APPLICATION NO.	FILING DATE	FIRST NAMED INVENTOR	ATTORNEY DOCKET NO.	CONFIRMATION NO.
10/590,587	10/25/2006	Hideki Watanabe	S004-5852 (PCT)	8549
<div>7590 Bruce L Adams Adams & Wilks 17 Battery Place-Suite 1231 New York, NY 10004</div>			<div>EXAMINER COLILLA, DANIEL JAMES</div>	
			<div>ART UNIT 2854</div>	<div>PAPER NUMBER</div>
			<div>MAIL DATE 06/25/2010</div>	<div>DELIVERY MODE PAPER</div>

Office Action Summary	Application No. 10/590,587	Applicant(s) WATANABE ET AL.	
	Examiner Daniel J. Colilla	Art Unit 2854

DETAILED ACTION

rotationally driving the platen roller 6 as shown below in the figure taken from Fig. 8 of

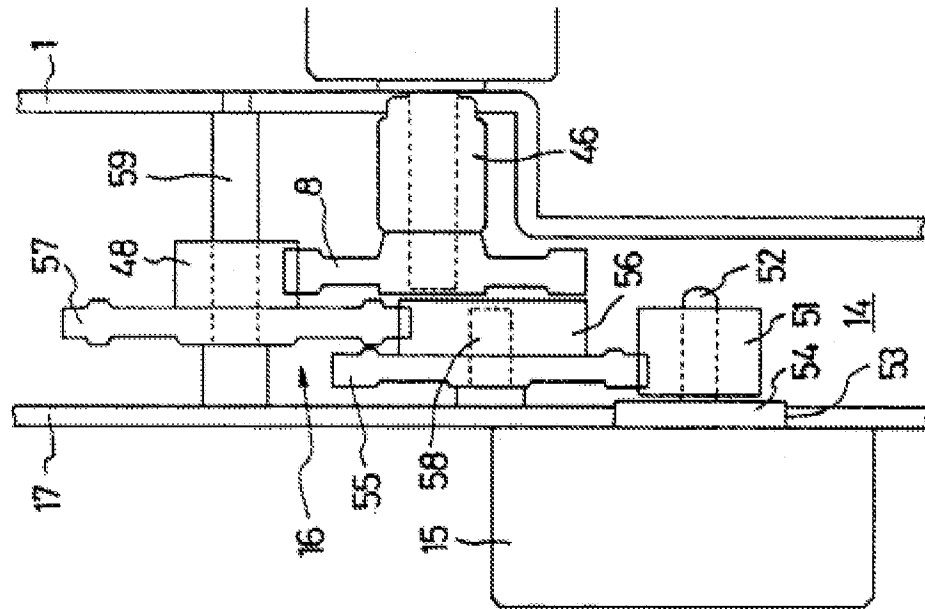
3. Claim 7 is rejected under 35 U.S.C. 102(b) as being anticipated by Saito *et al.* (US 5,198,836).

With respect to claim 7, Saito *et al.* discloses a printer, comprising:

Saito *et al.* discloses that the preassembled drive unit comprises a support member 17 integrally formed with gear support shafts 58 and 59 (Saito *et al.*, col. 11, lines 5-16), a rotary motor 15 supported by the support member 17 and having a drive gear 51, and idler gears 55 and 57 rotatably mounted on respective gear support shafts 58 and 59 for transmitting rotational movement of the drive gear 51 to the platen roller 6, the drive gear 51 and the idler gears 55 and 57 being disposed in a space defined by the gear support member 17 and the one side wall 1 as shown above.

【図5】

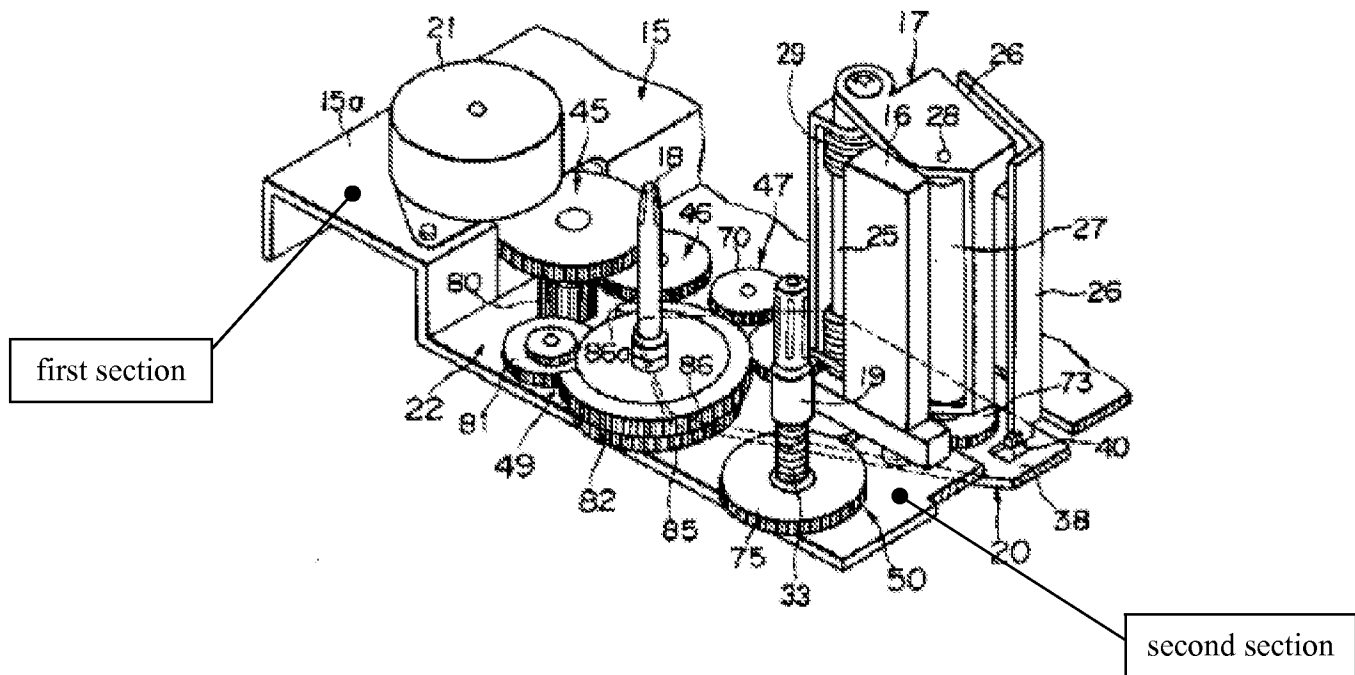
5. Claim 12 is rejected under 35 U.S.C. 103(a) as being unpatentable over Saito *et al.* (US 5,198,836), as applied to claim 7 above, further in view of Miyazaki (JP 9-086000).

With respect to claim 12, Saito *et al.* discloses the claimed printer except for the first support member section being offset from a second support member section. However, Miyazaki teaches a printer with a motor for driving a platen including a support member having a first section to which the rotary motor 21 is mounted, and a second section offset from the first section and from which gear support shafts extend (although gear support shafts are not shown, the gears must inherently be supported by shafts of some type) as shown below in the Figure taken from Fig. 5 of Miyazaki:

It would have been obvious to combine the teaching of Miyazaki with the printer disclosed by Saito *et al.* for the advantage of providing the motor and gears on the same side of the support so that they disclosed easily be serviced together.
